Value Engineering Study

Final Report

VE Number: 202303

I-75 Widening, MP 20.2 to MP 28.851 Laurel & Whitley Counties

VALUE PROPOSAL

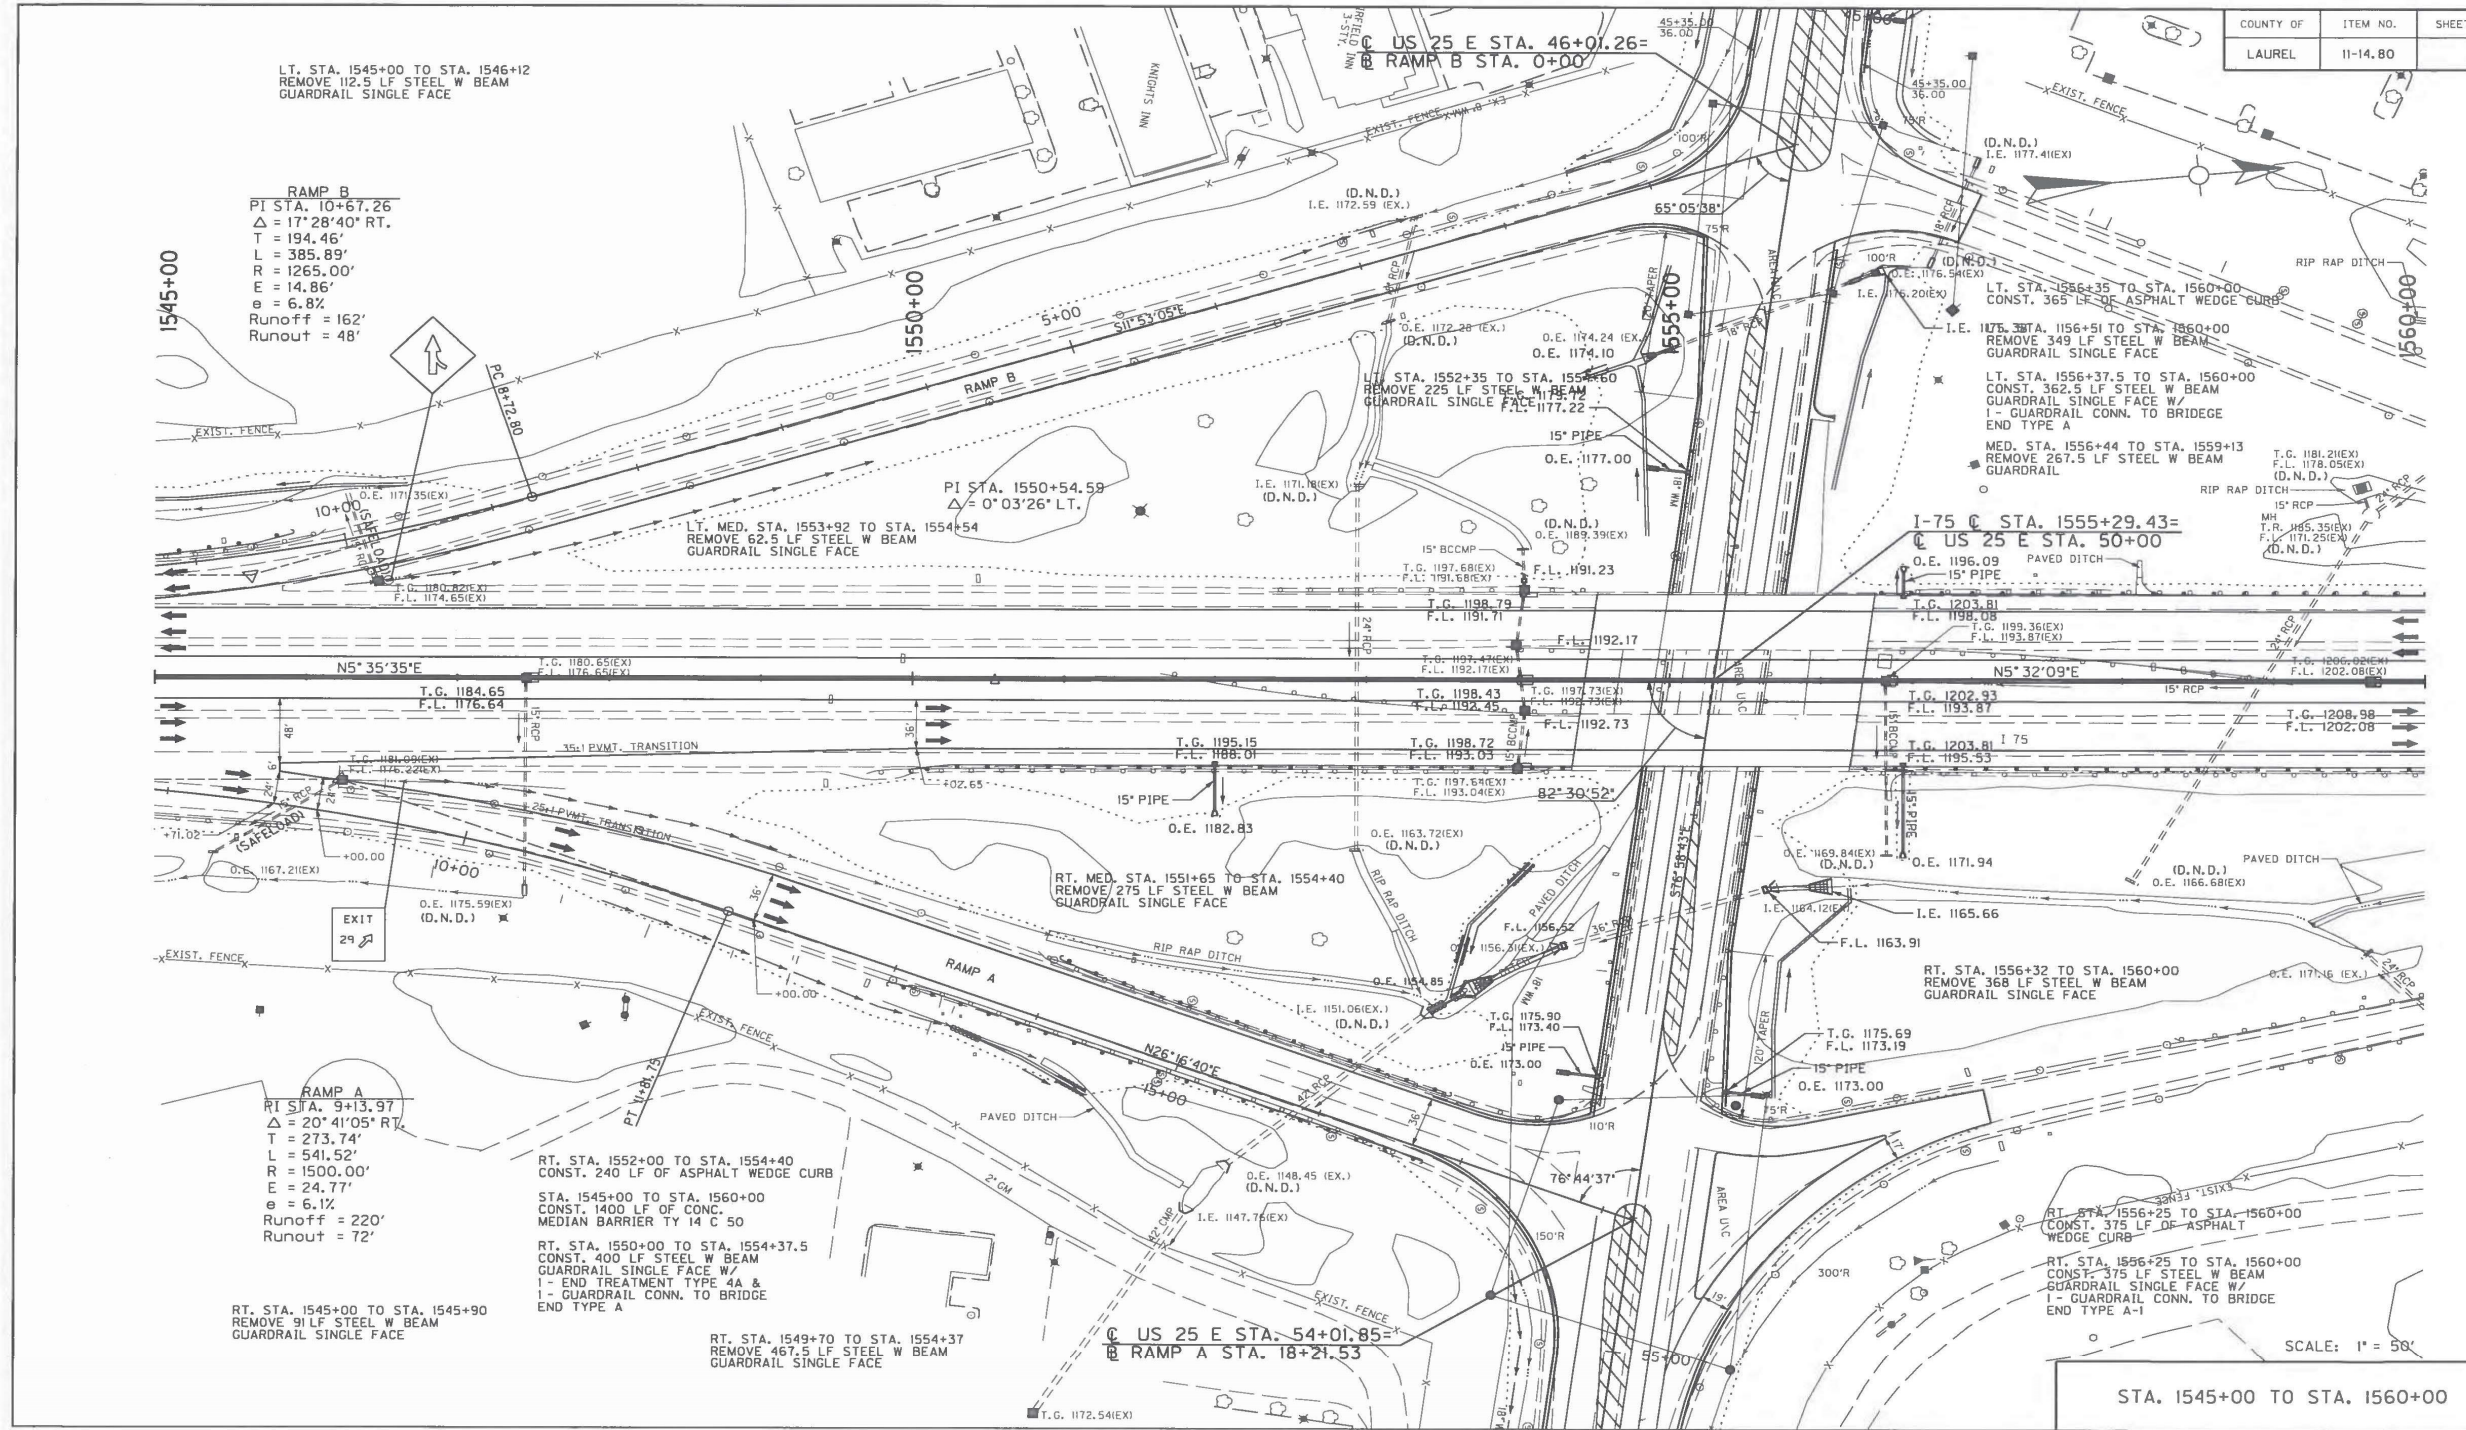
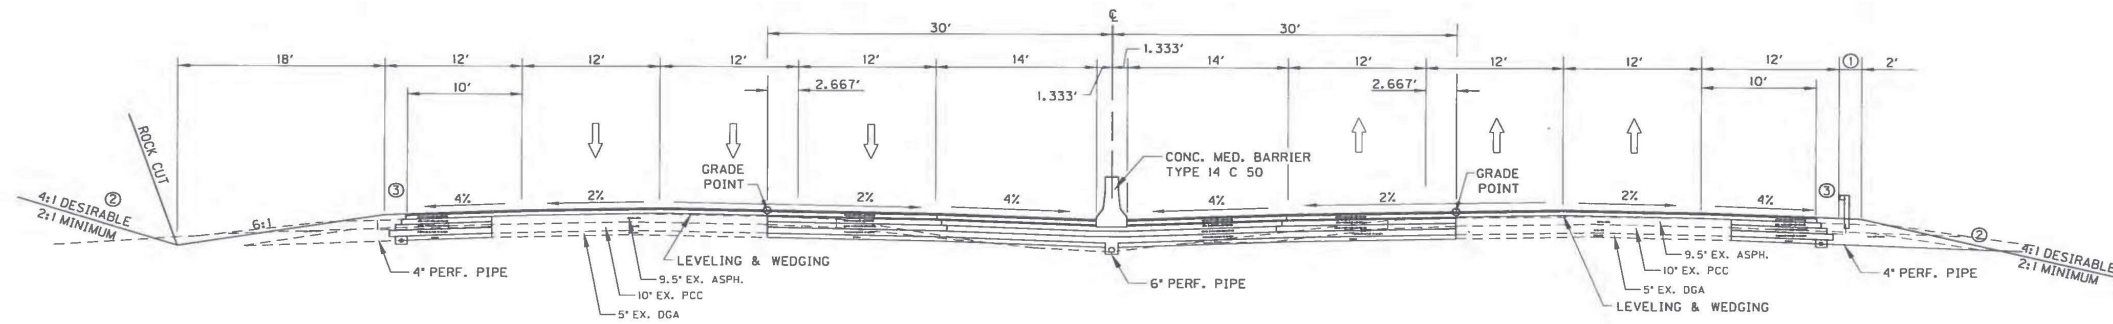
TITLE	Construct the Exit 29 intersection as a double crossover diamond to maintain the existing bridge and improve movement		
VALUE PROPOSAL SYNOPSIS:			
Widen the existing I-75 overpass instead of constructing a new bridge. Utilizing a Diverging Diamond Interchange to address capacity issues on US 25E while fitting the typical section within the existing piers.			
 Reliability	Maintained	 Functionality	Improved
 O&M	Maintained	 Schedule Impact	Improved
			\$ Initial Cost Avoidance (Add)
			\$2,037,000
BASELINE CONCEPT:			
Reconstruct the Exit 29 overpass with a new 3 span bridge and provide dual left turns in eastbound and westbound direction on Us 25E			
VALUE PROPOSAL DESCRIPTION:			
Build a Double Diveraging Diamond Interchange. Widen the existing overpass to accomodate the I-75 widening.			
ADVANTAGES:		DISADVANTAGES:	
● Dont need to lengthen spans.		● Drivers may not be familiar with configuration

03

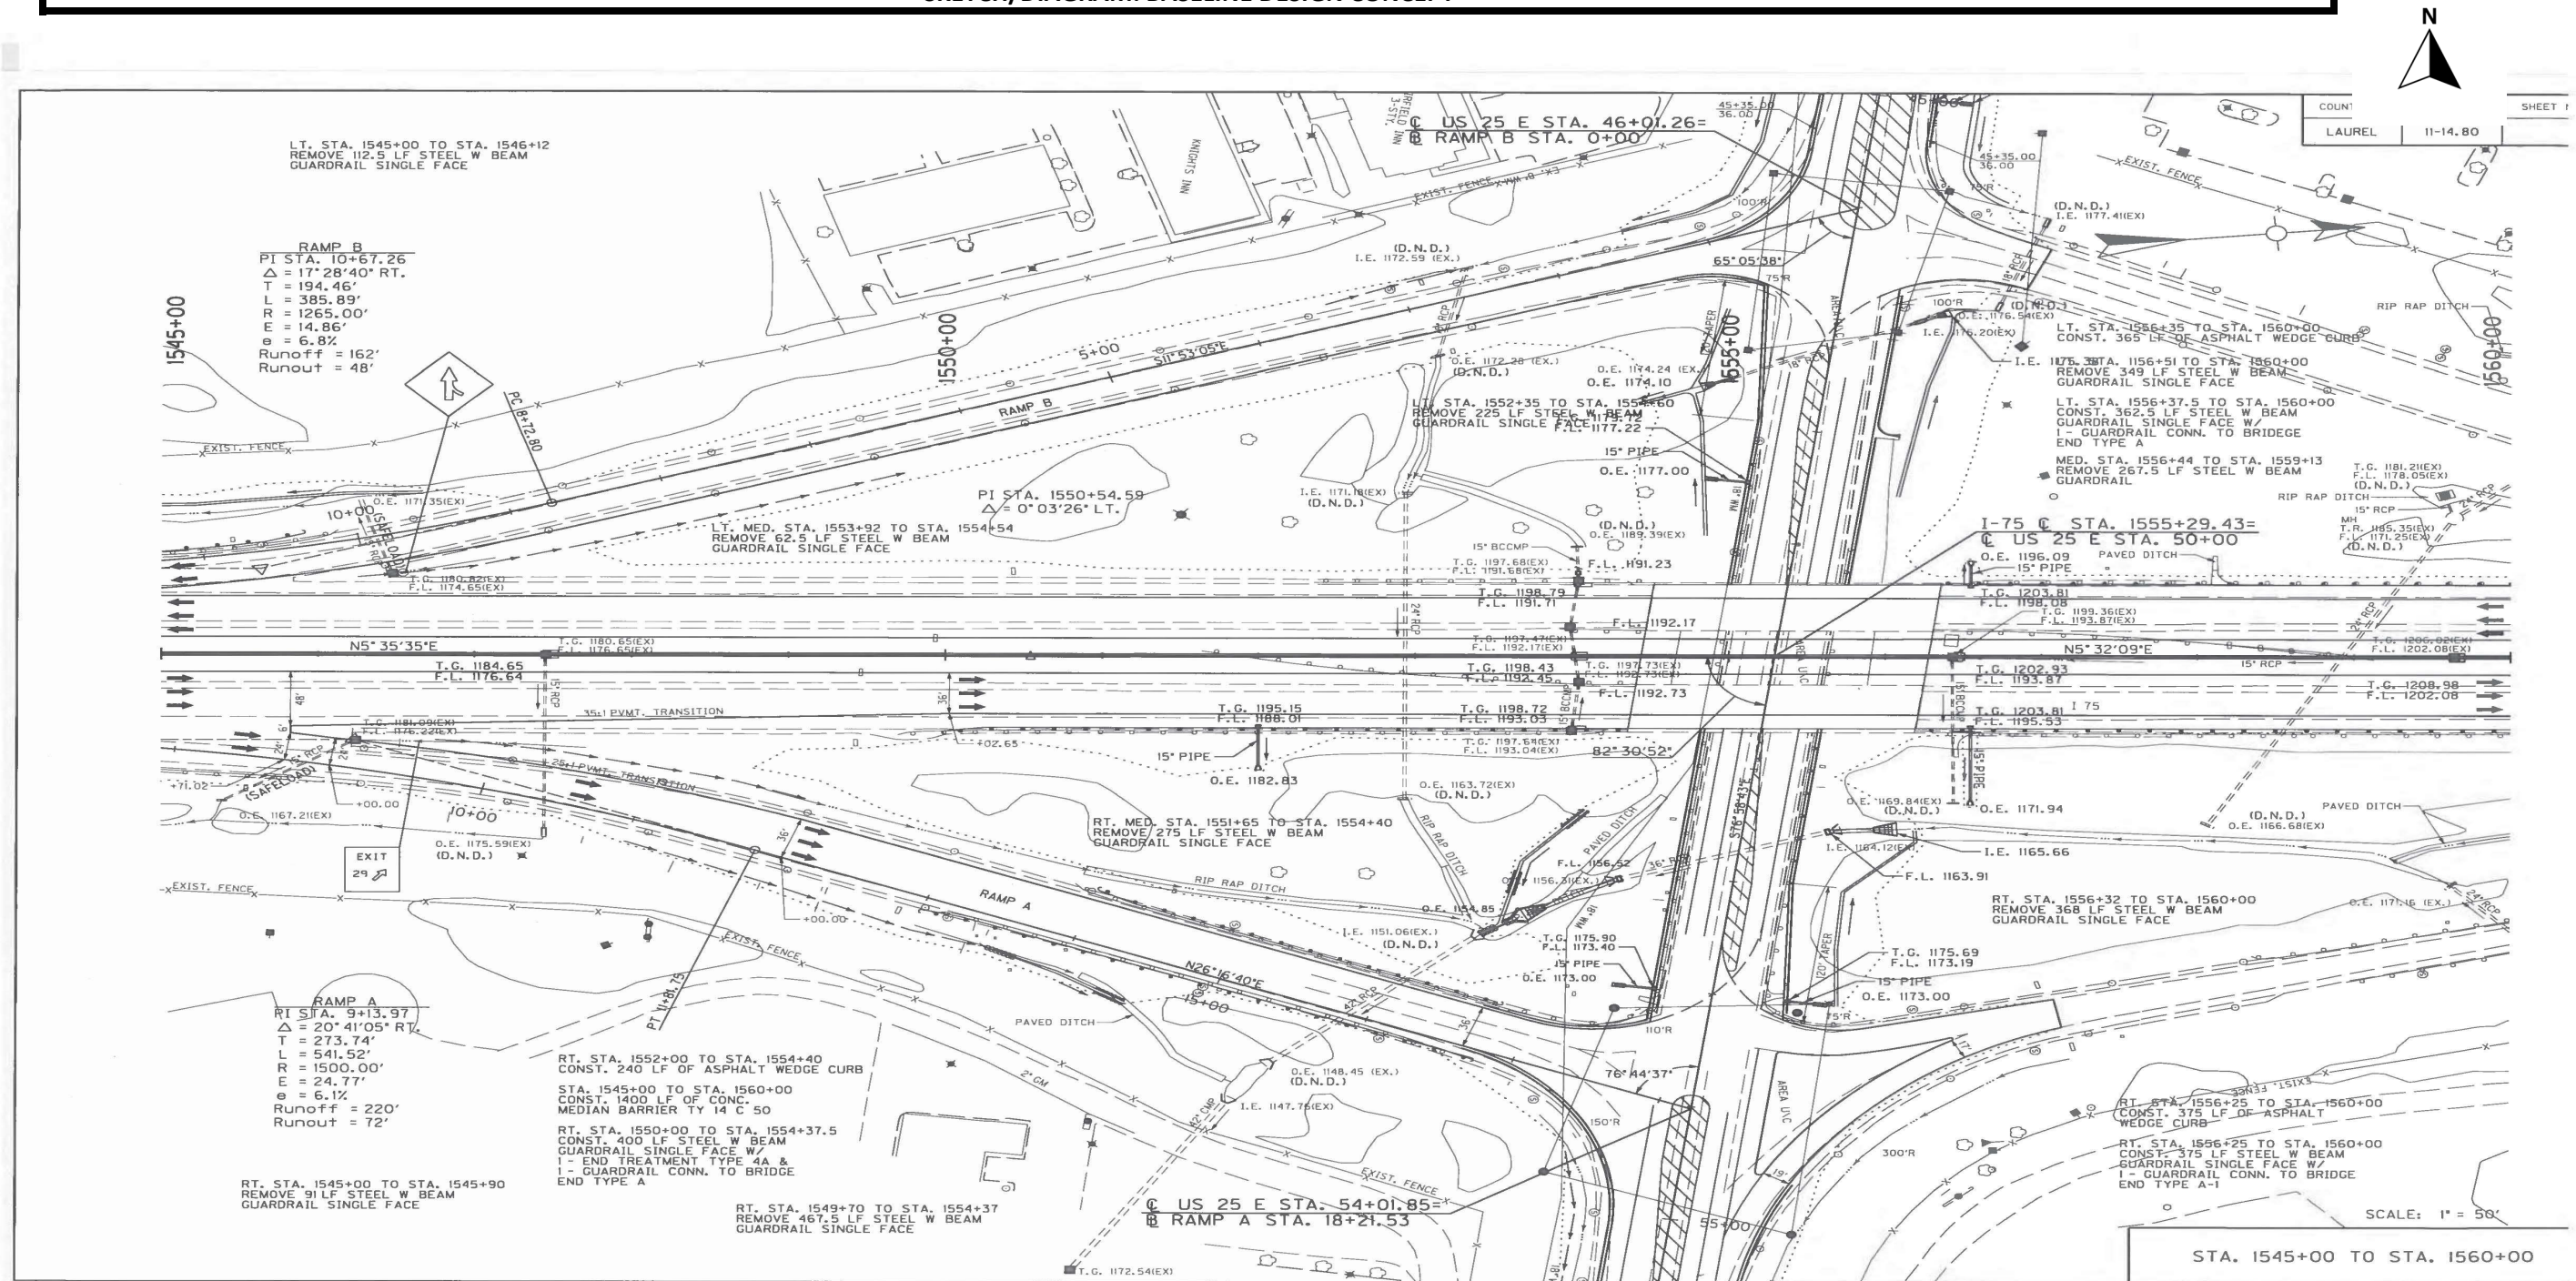
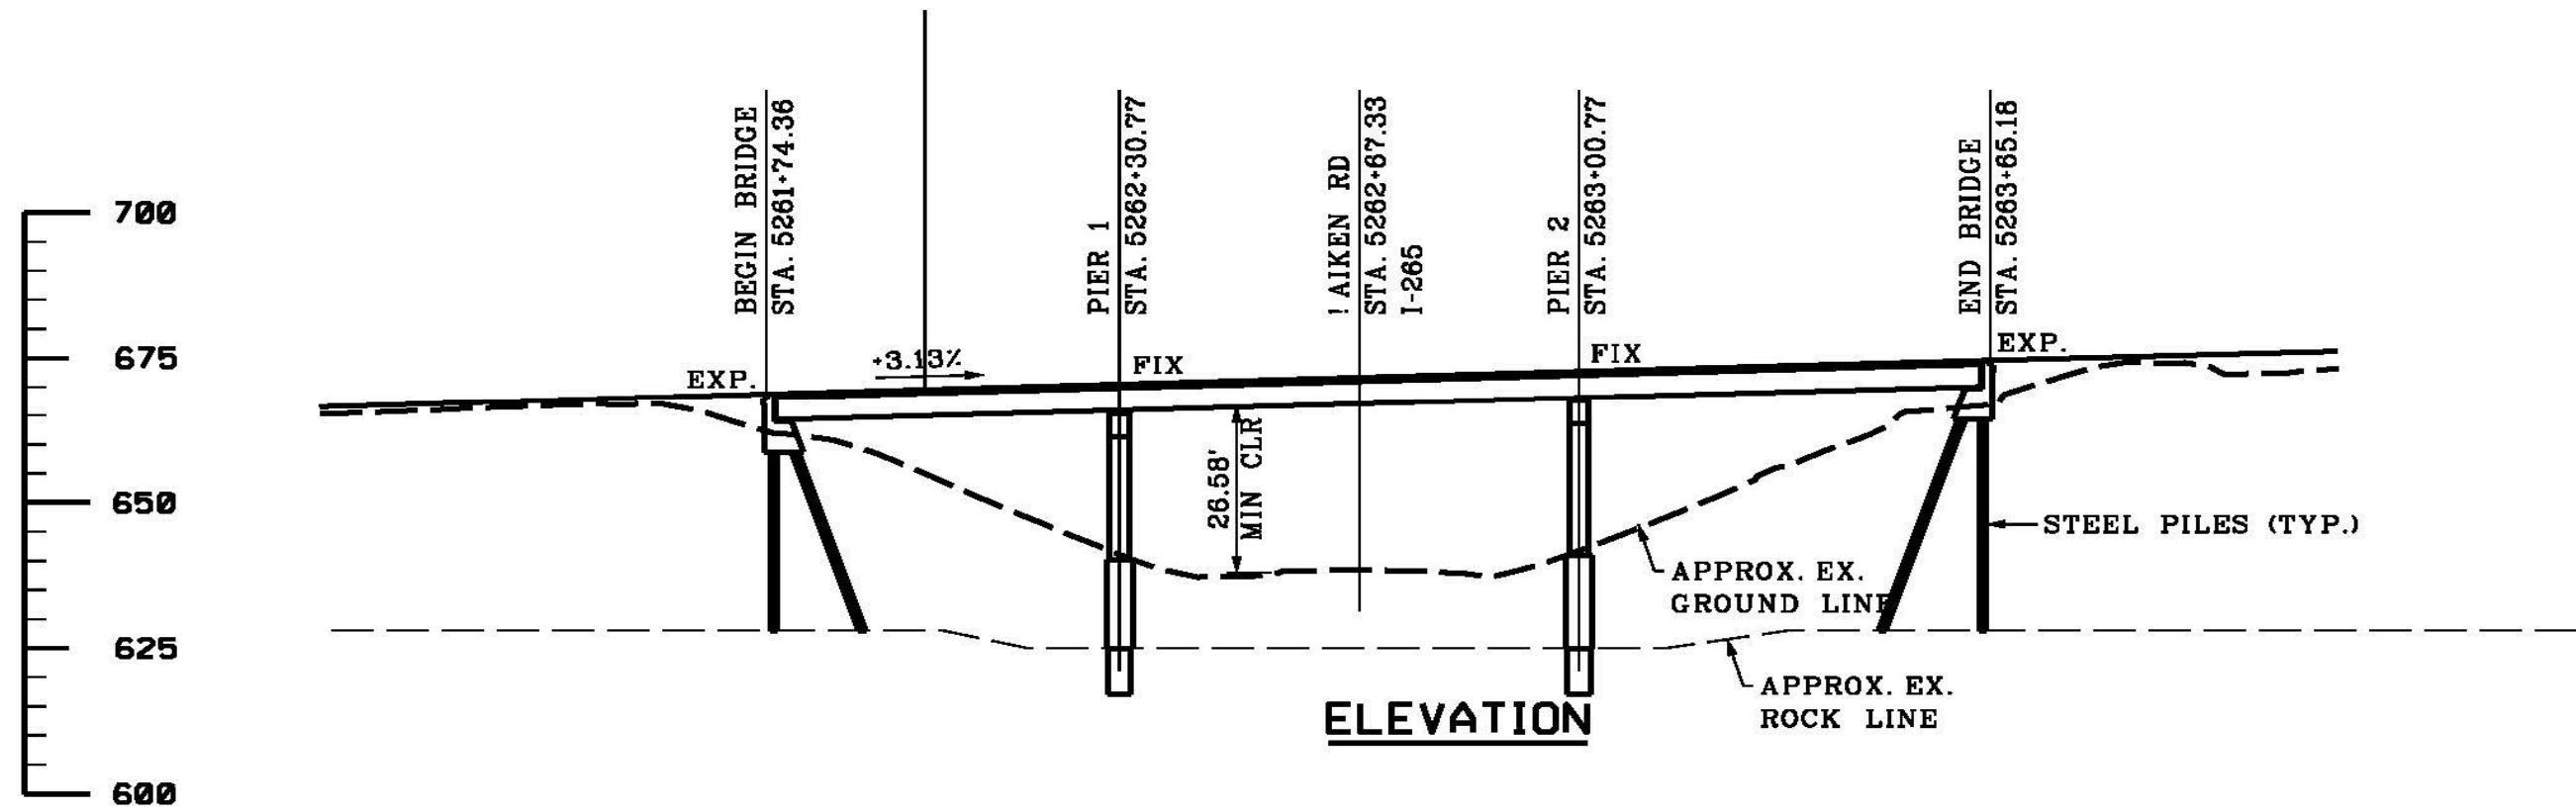
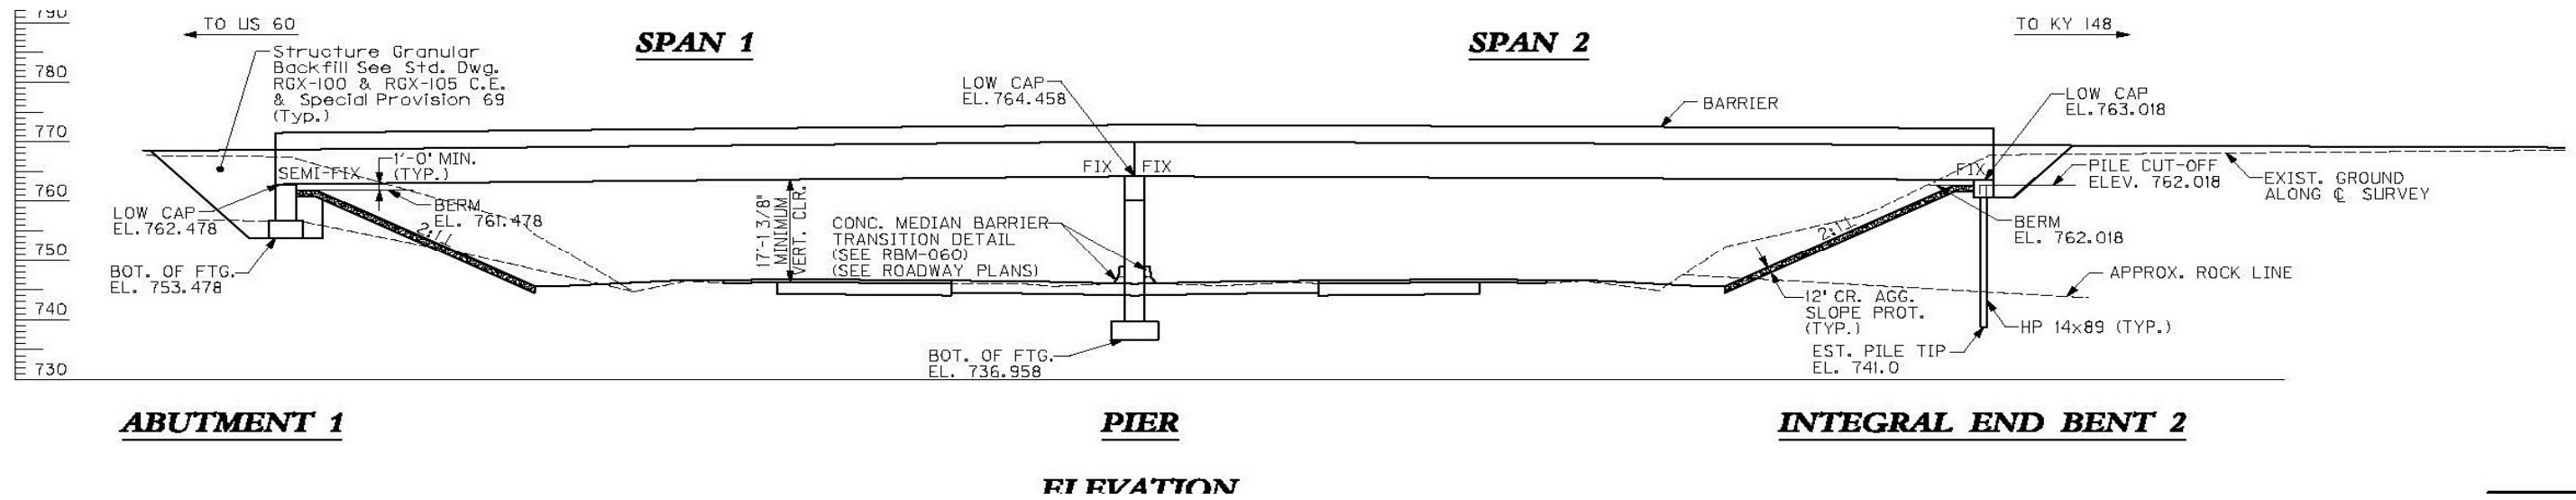
TITLE	Construct the Exit 29 intersection using a two span construction with different pier placement		
VALUE PROPOSAL SYNOPSIS:			
Utilize a 2 span configuration for the replacement bridge at exit 29 (I75 over US25E)			
 Reliability	Maintained	 Functionality	Improved
 O&M	Improved	 Schedule Impact	Improved
			\$ Initial Cost Avoidance (Add)
			\$700,000
BASELINE CONCEPT:			
Currently the bridge over US25E is a four span bridge with piers in the middle of US25E and at each shoulder. KYTC request a new design that removed the center line (that separates the lanes of US25E). the likely method of removing the center pier is with a 3 span configuration with piers to each side of US25E.			
VALUE PROPOSAL DESCRIPTION:			
Cost savings can be generated by reducing the number of piers from 2 to 1. The beams and other roadwork cost should be similar to the 3 span option.			
ADVANTAGES:		DISADVANTAGES:	
<ul style="list-style-type: none"> ● Reduced cost 		<ul style="list-style-type: none"> ● Leaves pier in the middle of US25E which will necessitate an enhanced roadway intersection design.

TITLE Construct the Exit 29 intersection using a two span construction with different pier placement
